CAPITAL PROGRAM SERVICES
5750 ALMADEN EXPRESSWAY
SAN JOSE, CA 95118-3686
TELEPHONE (408) 630-3004
FACSIMILE (408) 979-5631
www.valleywater.org
scvwdplanroom@valleywater.org

**ADDENDUM NO. 1
TO CONTRACT DOCUMENTS FOR
THE BOLSA ROAD FISH PASSAGE IMPROVEMENT PROJECT
Project No. 26044002 Contract No. C0652**

Notice is hereby given to Prospective Bidders that the Contract Documents are modified as hereinafter set forth.

DETAIL 1 BANK PROTECTION
C-04 SCALE: NTS

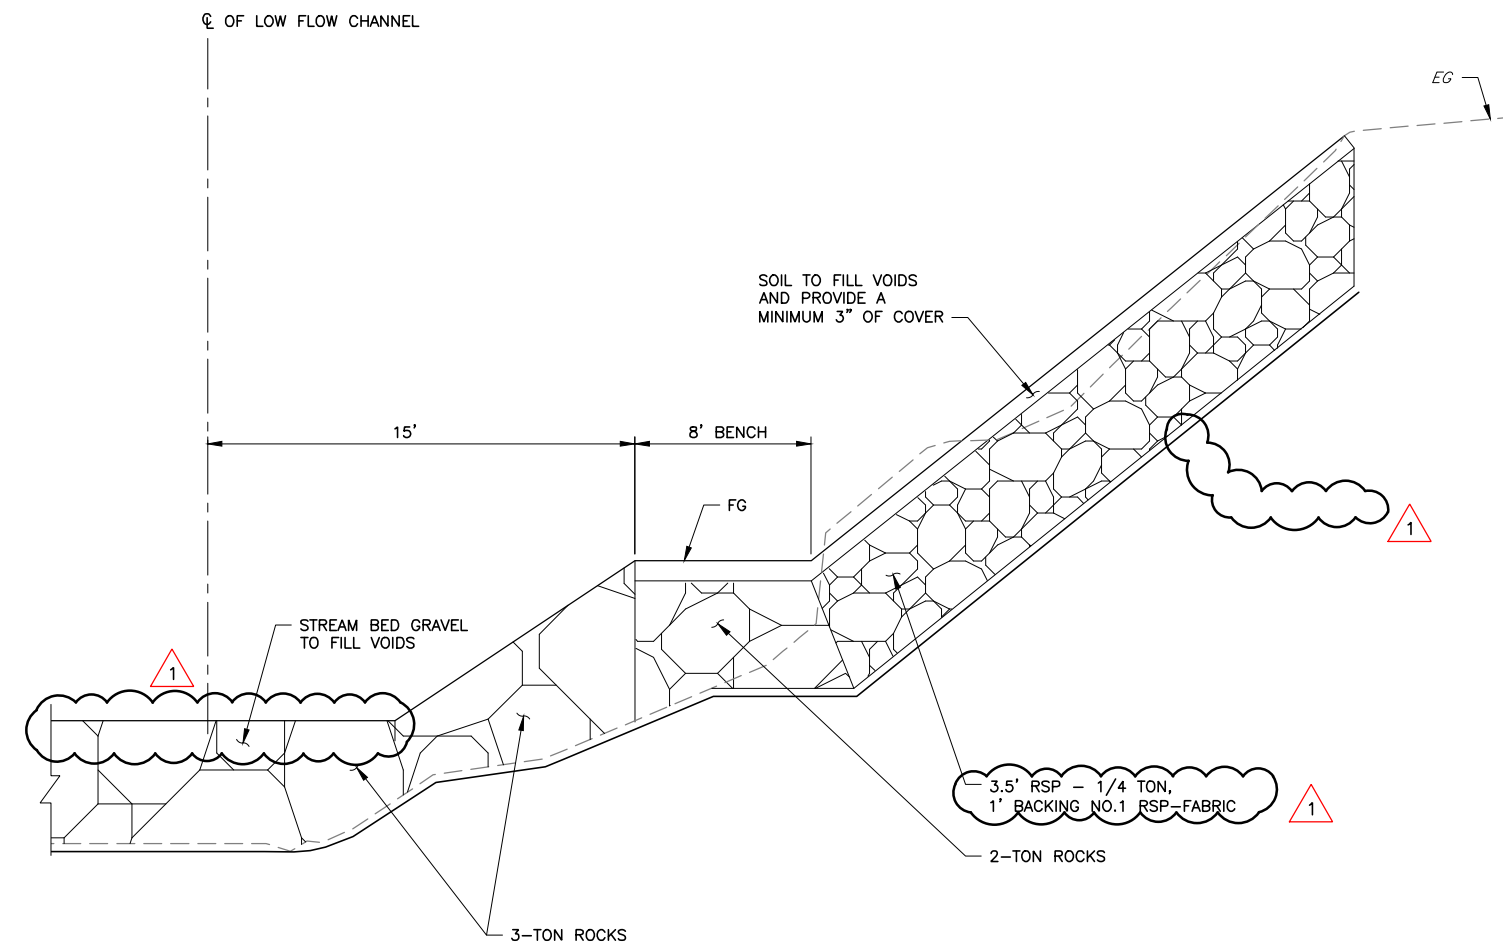
Question 8	Please provide dimensions of Bank protection for both left and right side of the creek including depth of rock beds per detail 1/C-04
Response 8	Please refer to revised drawing Sheet C-04.

Question 9	Please provide bid item number for Bio-engineered slope per detail 1/C-04.
Response 9	Title of detail 1 is revised to "Bank Protection Slope" and shall be considered as Bid Item No. 6, Rock Slope Protection.

Question 10	In detail 1/C-04 please provide thickness of stream bed gravel to fill voids.
Response 10	Please refer to revised Drawing C-04; no additional thickness of stream bed gravel shall be placed above finish grade of channel bed.

SECTION A – TYP ROCK LAYOUT FROM TOP OF RIFFLE TO RIFFLE
SCALE: HORIZ 1" = 10' VERT 1" = 2'

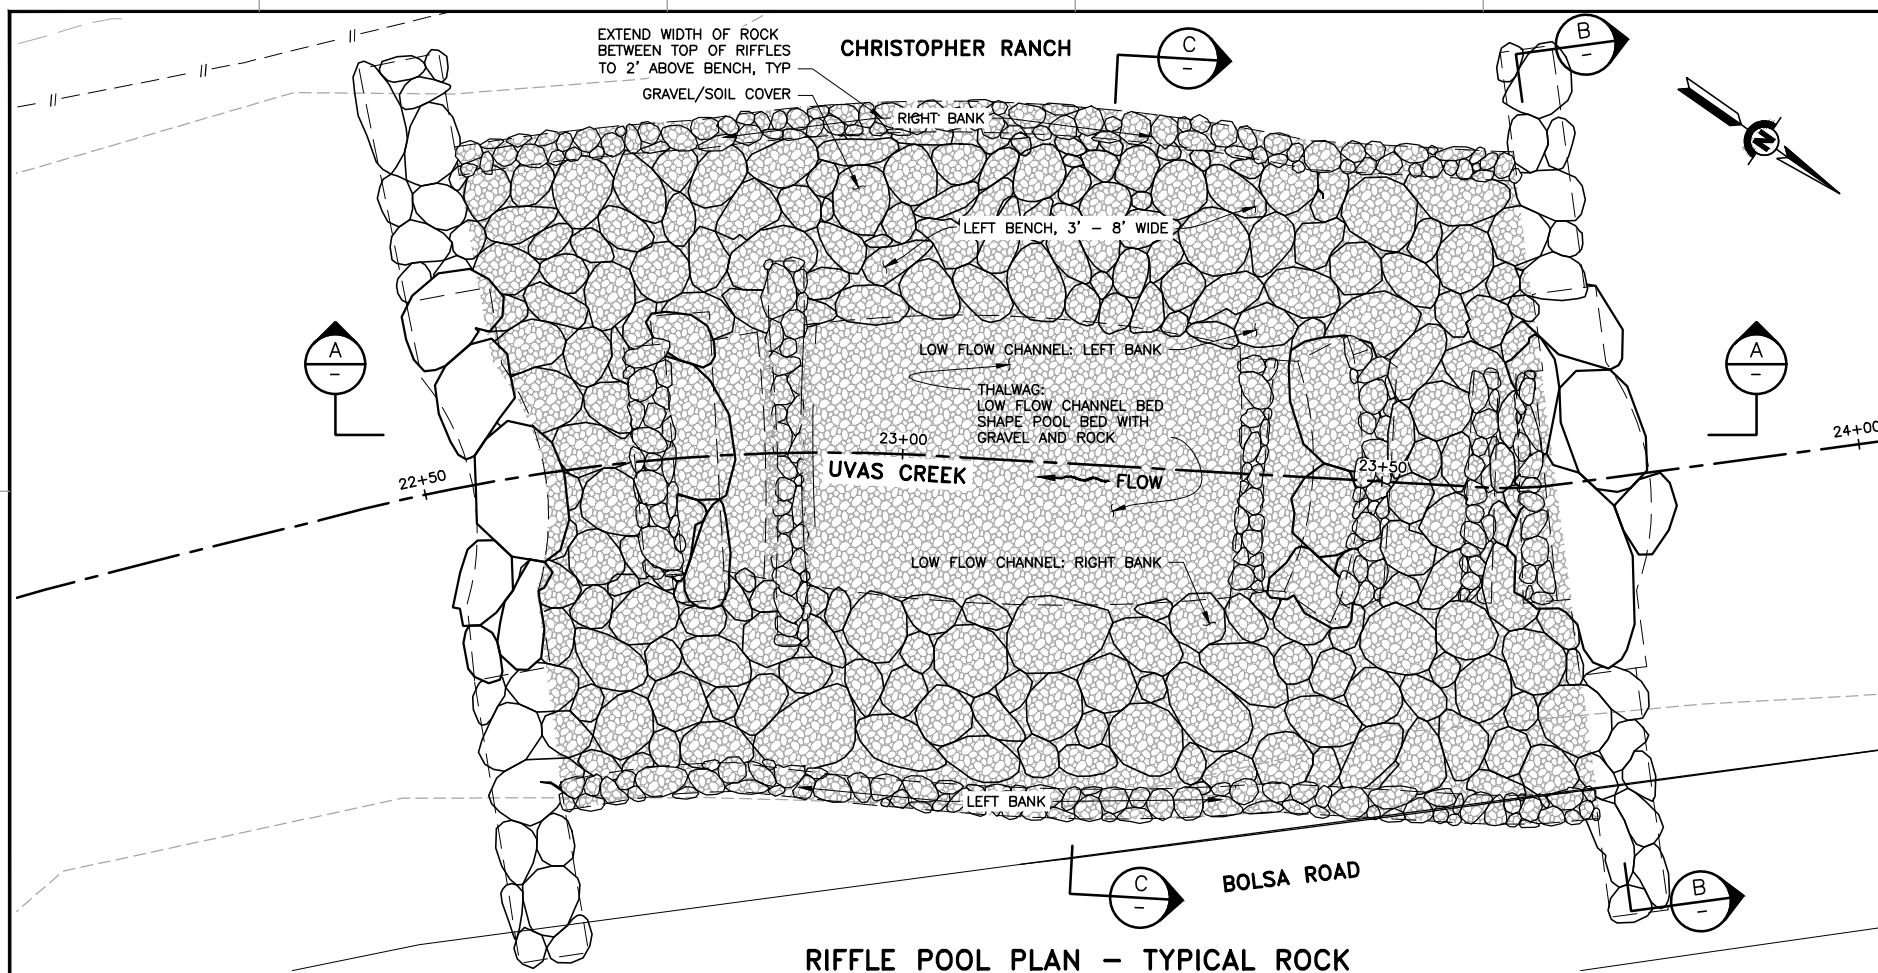
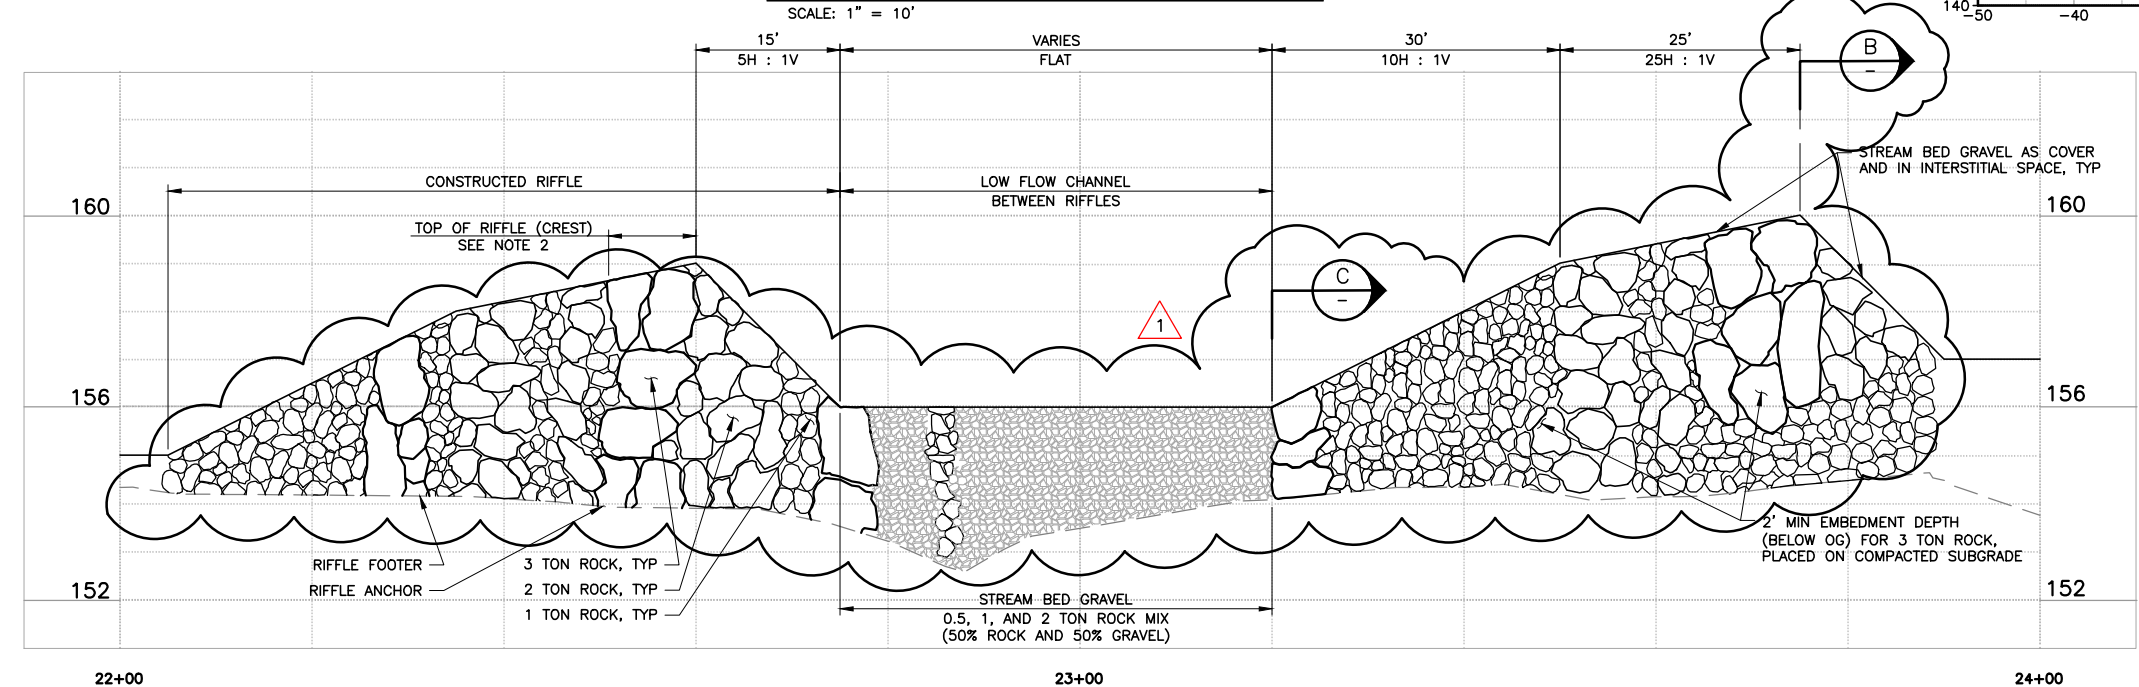
Response 2	Please refer to ATTACHMENT 1, Bid Form No 1 (REV 1) Proposal and Bid Items of this Addendum No. 2, Section A, Base Bid table.
Question 3	Section A in C-05 shows that thickness and width of the Riffle at the flow channel. Is this the same at the left and right banks. If not, please provide cross section at the right and left bank.

Question 15	In detail A/C-05 please provide detail of the riffle beyond the left and right banks.
Response 15	Section B on Sheet C-05 provide the layout of riffle boulder along the top of riffle indicating across the channel.

Response 3	Please refer to revised drawings (ATTACHMENT 2). Yes, the left and right banks of the top of riffle are in general the same; Section B also provides the boulder layout configuration.
